Project	IEEE 802.16 Broadband Wireless Access Working Group < http://ieee802.org/16 >	
Title	Comments on MS ranging and network entry in non-transparent RS systems under centralized scheduling	
Date Submitted	2007-09-09	
Source(s)	Kanchei (Ken) Loa, Yi-Hsueh Tsai, Yung-Ting Lee, Hua-Chiang Yin, Shiann-Tsong Sheu, Youn-Tai Lee, Institute for Information Industry 8F, No. 218, Sec. 2, Dunhua S. Rd., Taipei City 106, Taiwan [add other coauthors here]	Voice: +886-2-27399616 Fax: +886-2-23782328 loa@iii.org.tw
Re:	IEEE 802.16j-07/043: "IEEE 802.16 Working Group Working Group Letter Ballot #28"	
Abstract	Comments on mechanism that RS locally broadcast RNG-RSP message(s) on the access link	
Purpose	Text proposal for 802.16j Draft Document.	
Notice	<i>This document does not represent the agreed views of the IEEE 802.16 Working Group or any of its subgroups. It represents only the views of the participants listed in the "Source(s)" field above. It is offered as a basis for discussion. It is not binding on the contributor(s), who reserve(s) the right to add, amend or withdraw material contained herein.</i>

Comments on MS ranging and network entry in non-transparent RS systems under centraliz

Figure 1 Latencies during the ranging procedure for 2-hop and 3-hop scenarios

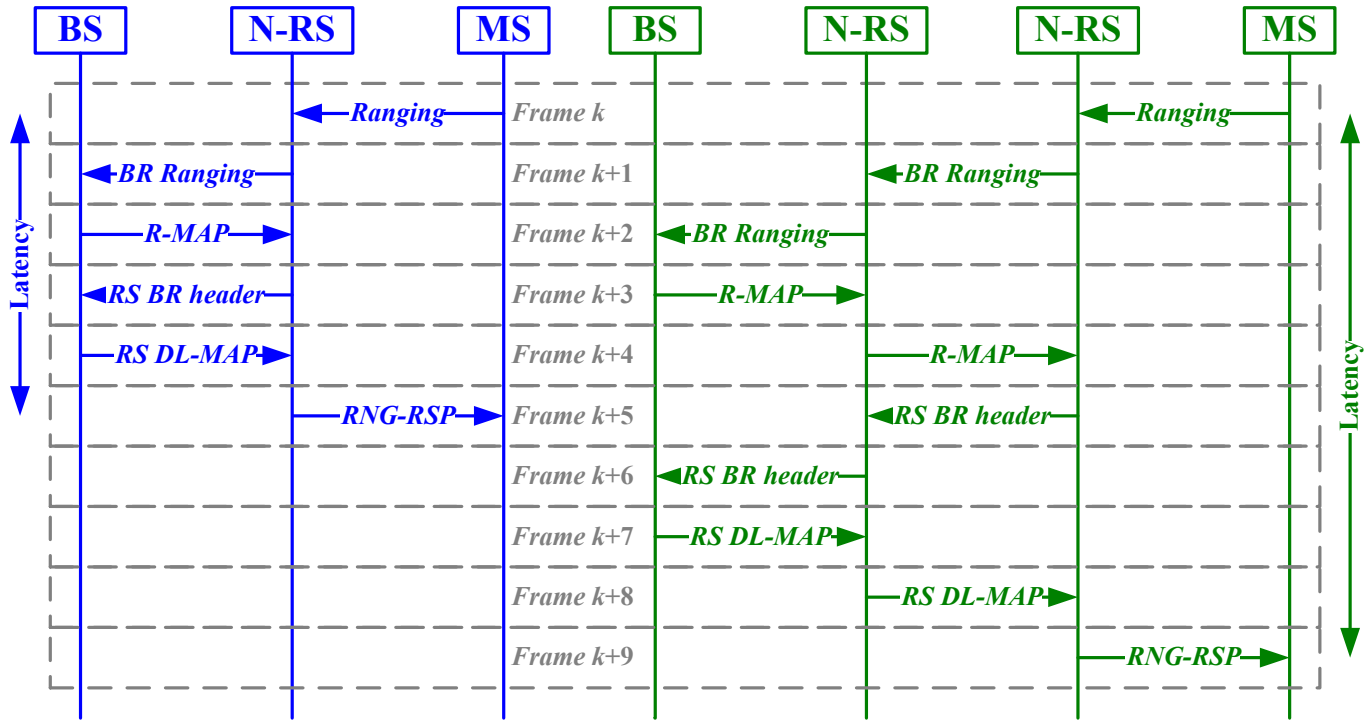
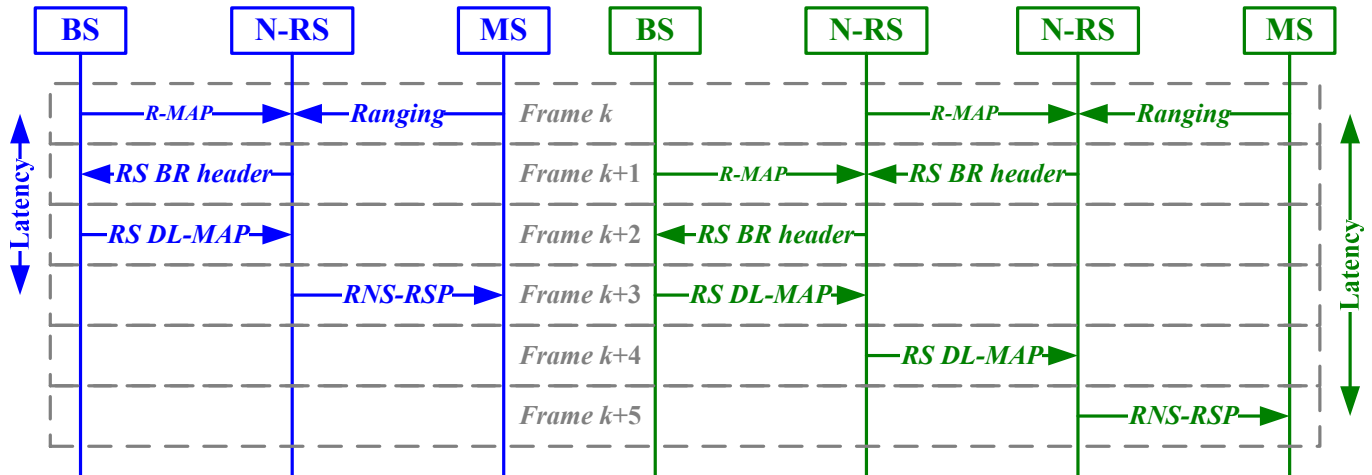
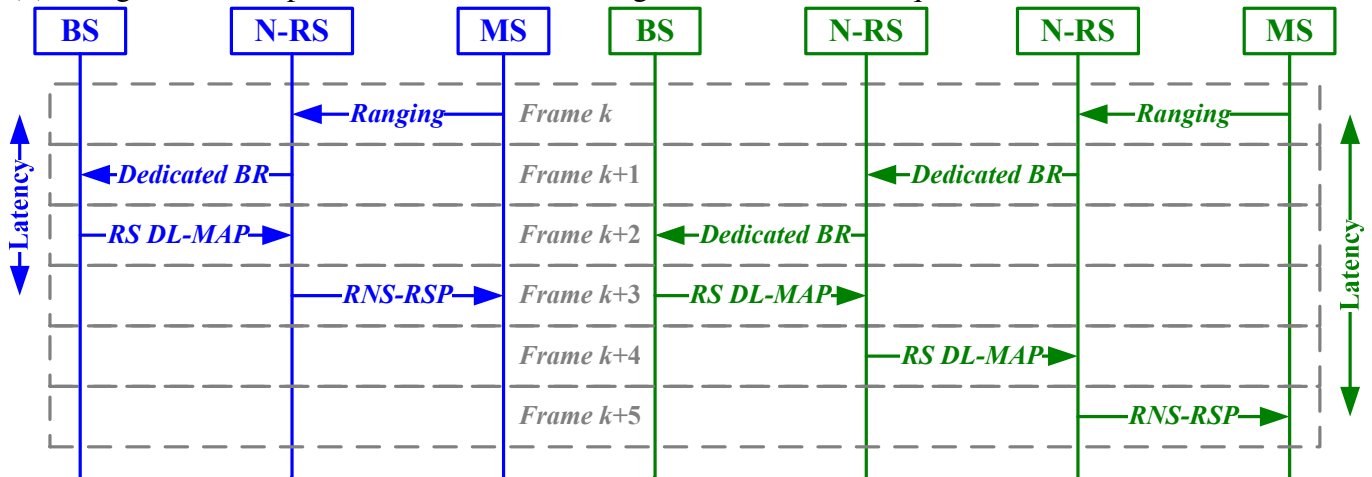
The response latencies for using anonymous ranging code for sending RS BR header (to request bandwidth to send RNG-RSP), using dedicated uplink bandwidth for sending RS BR header, and using dedicated ranging code for sending RNG-RSP are described in Figure 1 and Table 1. In Figure 1a, the minimum latency of CDMA ranging response for 2-hop and 3-hop are 5 and 9 frames (25 and 45 ms for 5-ms frame). Furthermore, the minimum latency with hop-count more than four is larger than 13 frames (65 ms for 5-ms frame) and becomes unacceptable since the T3 timer (60 ms for initial or periodic ranging) at MS side has already been expired. The comparisons of response latency are described in Table 1. In order to resolve this issue, we recommend using Feedback Polling IE or dedicated ranging code to shorten the latency (see Figure 1b and 1c), where the minimum response latency for 2-hop and 3-hop scenario are 3 and 5 frames (i.e., 15 and 25 ms for 5-ms frame), respectively.

Figure xxx-b Handling CDMA ranging code at a non-transparent RS

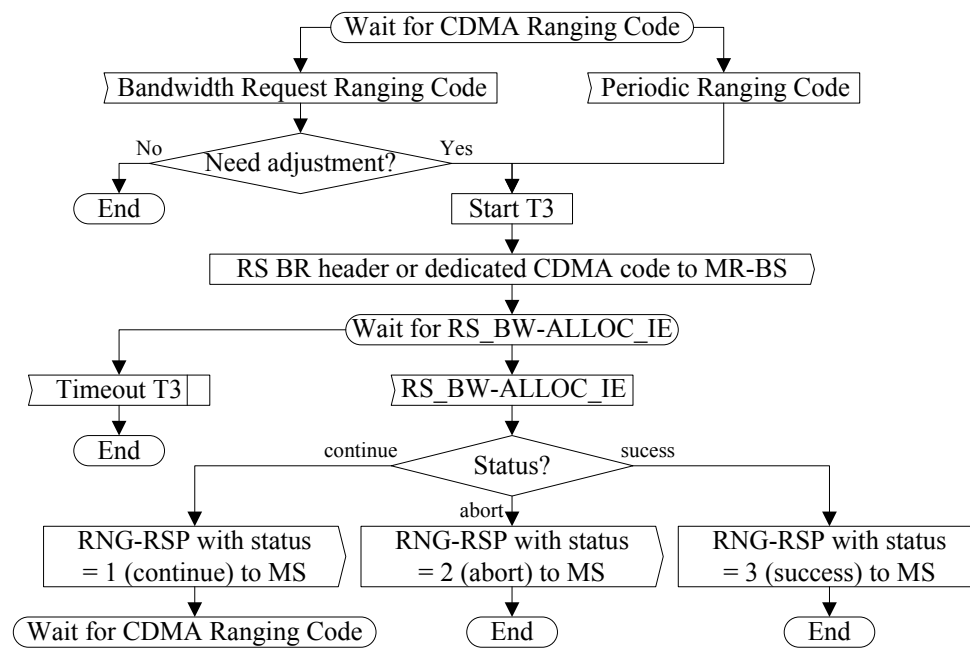
[Merge Figure 108c and Figure 108j, and move it to 6.3.10.3.7.2 as following indicated:]
